**DEVIATION REQUEST
AND DECISION FORM**

PPR-22-009

Project Name : Webster Elementary School Expansion
 Schedule No.(s) : 55193-13-001
 Legal Description : Tract A of Wilson's Widefield Addition No. 6

PAVING PLAN

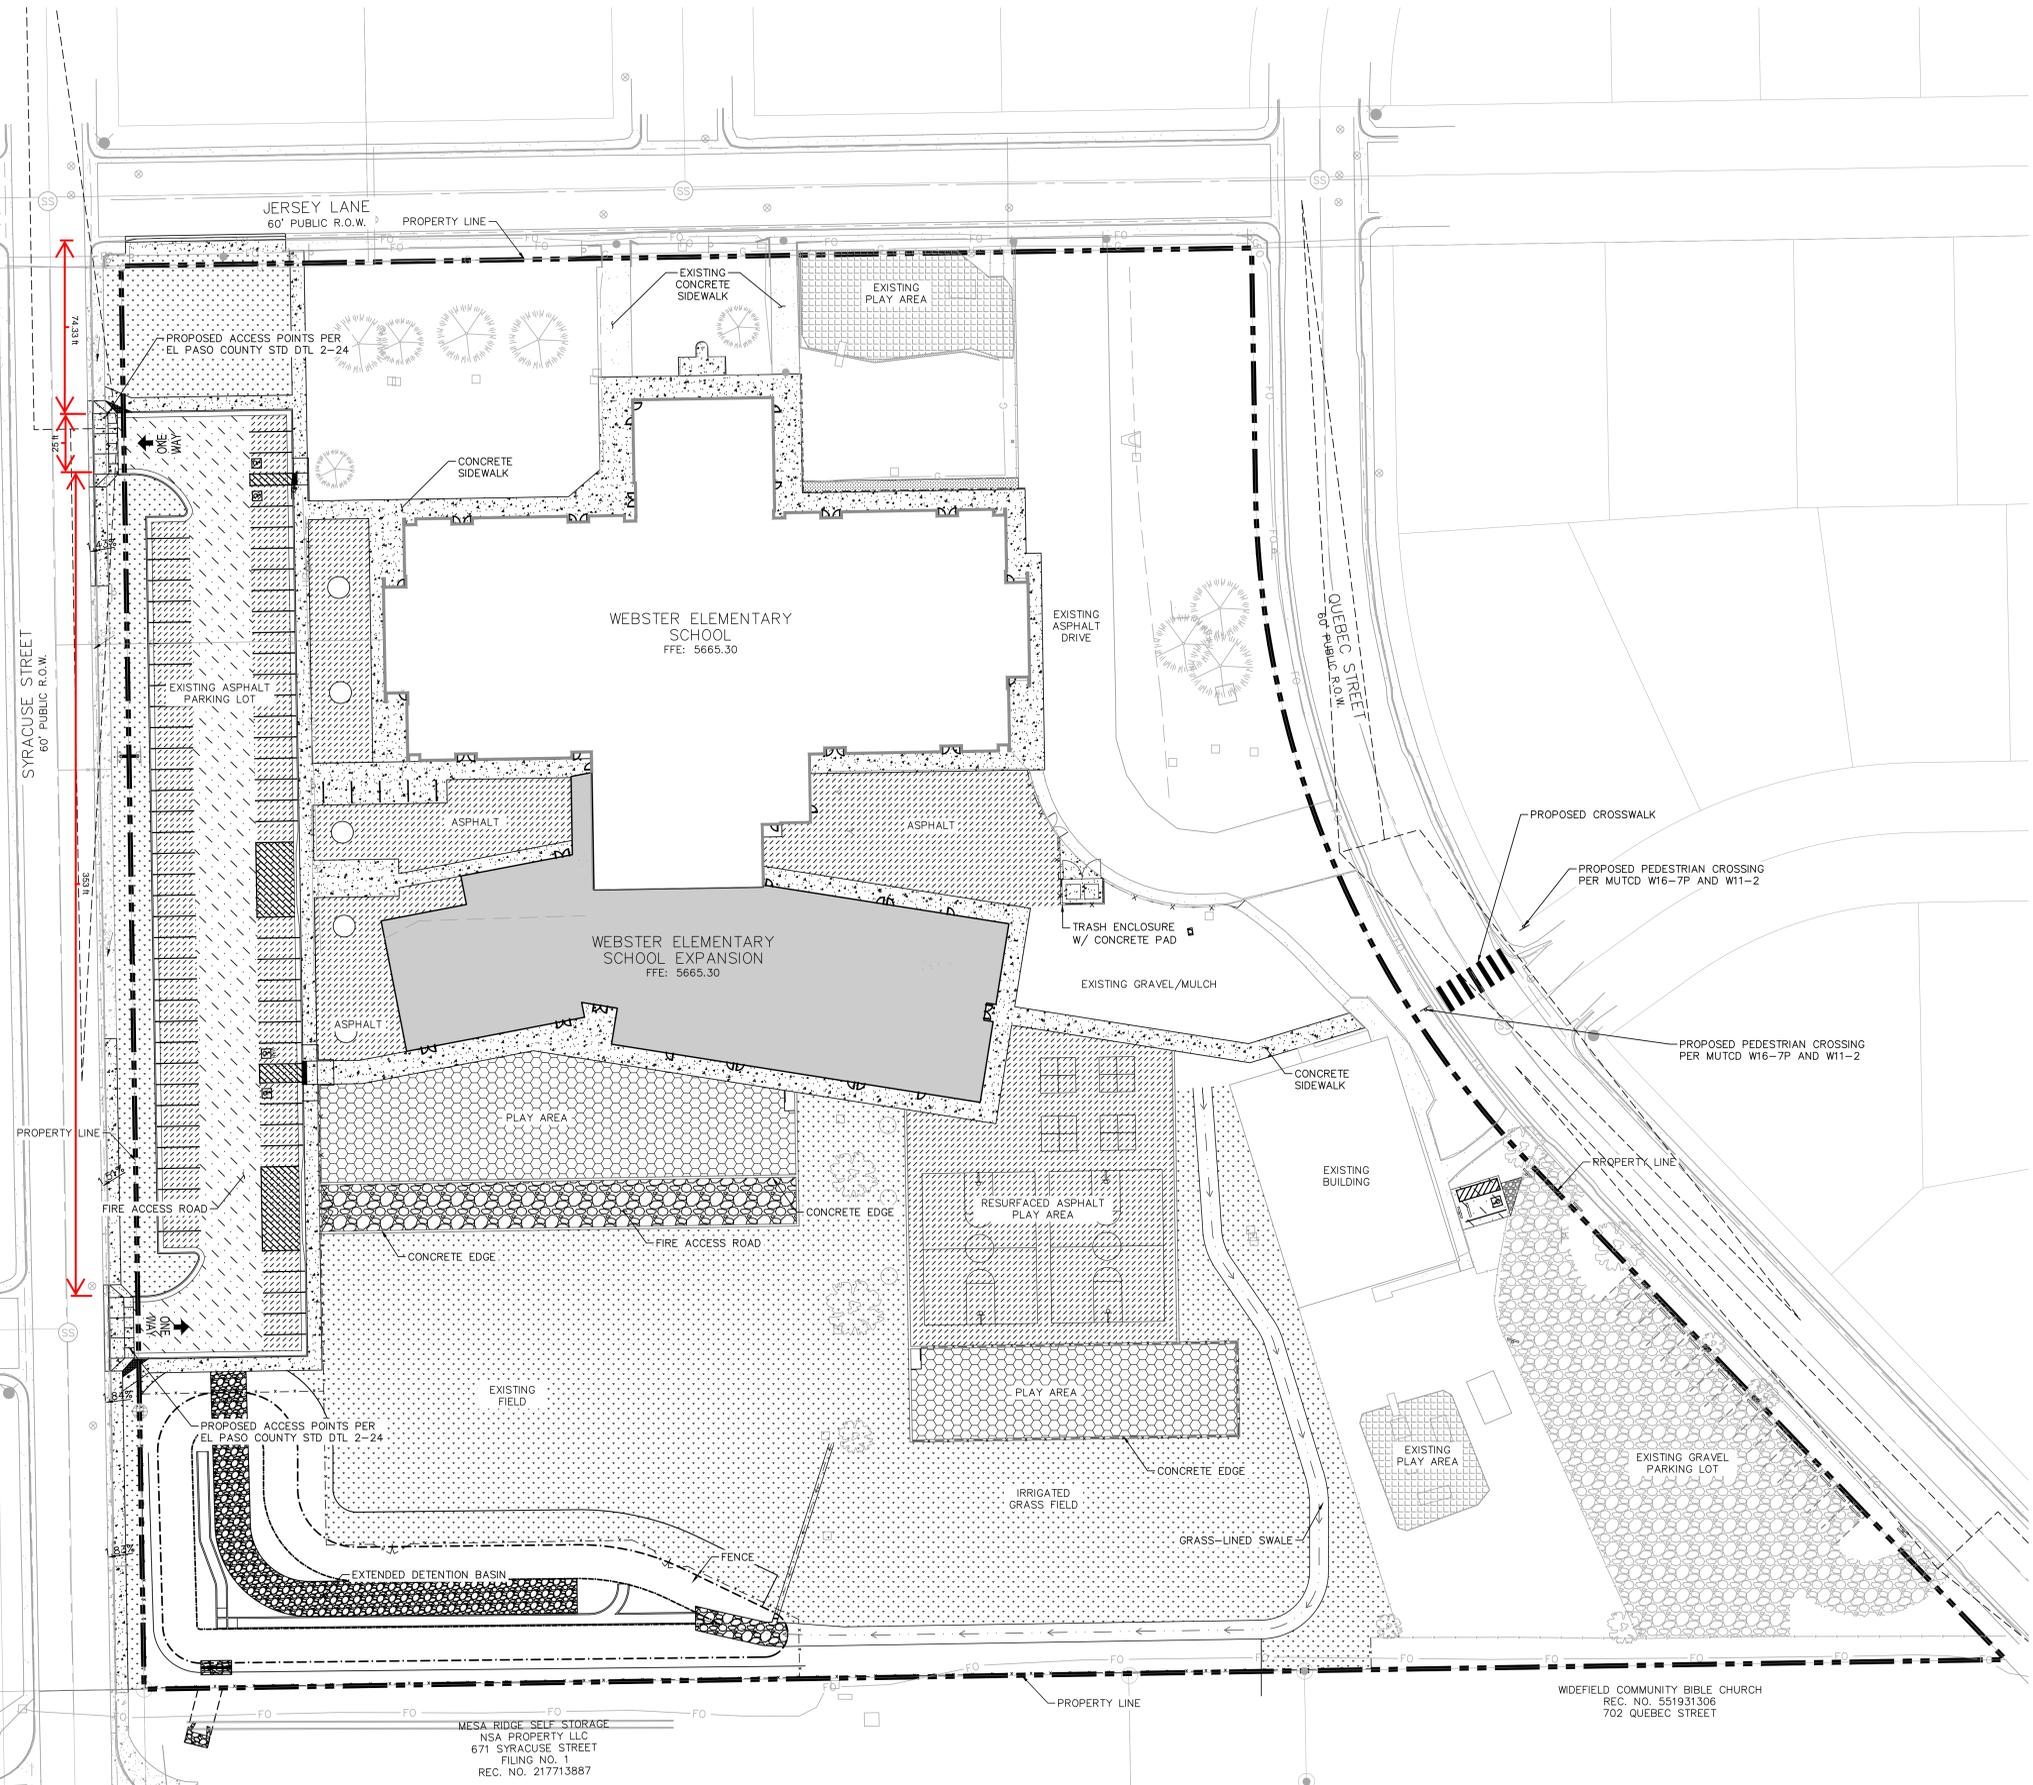
The deviation is requested to relocate the entrance only access along Syracuse Street to extend the length of internal circulation patterns for student pick-up/drop-off operations as well as increase the parking area for the school expansion.

The entrance only access along Syracuse Street to align with Fay Drive will be located approximately 215 feet north of James Madison Charter Academy Access. According to El Paso County ECM section 2.2.5.D, spacing along an urban residential collector roadway shall be spaced 330 feet to a local roadway. However, the character of Syracuse Street in this segment aligns more to a local street and not a collector street as it has driveways and houses fronting along Syracuse Street surrounding this location. Based on El Paso County ECM section 2.2.5.E (Rural and Urban Local Roadways), roads shall not intersect urban local roadways closer than 175 feet; therefore, with the character of a local street, this access intersection meets criteria for access spacing along an urban local roadway.

The character of Syracuse Street in this segment aligns more to a local street and not a collector street as it has driveways and houses fronting along Syracuse Street surrounding this location. Based on El Paso County ECM section 2.2.5.E (Rural and Urban Local Roadways), roads shall not intersect urban local roadways closer than 175 feet; therefore, with the character of a local street, this access intersection meets criteria for access spacing along an urban local roadway.

Based on the evaluation of vehicle crashes in the area, the proposed entrance only access intersection is not expected to impact safety in the area. Further, all movements at the intersection of Syracuse Street and Fay Drive/Project Access are expected to operate acceptably with level of service B or better.

This request has been determined to have met the criteria for approval. A deviation from Section 2.2.5.D of the ECM is hereby granted based on the justification provided.
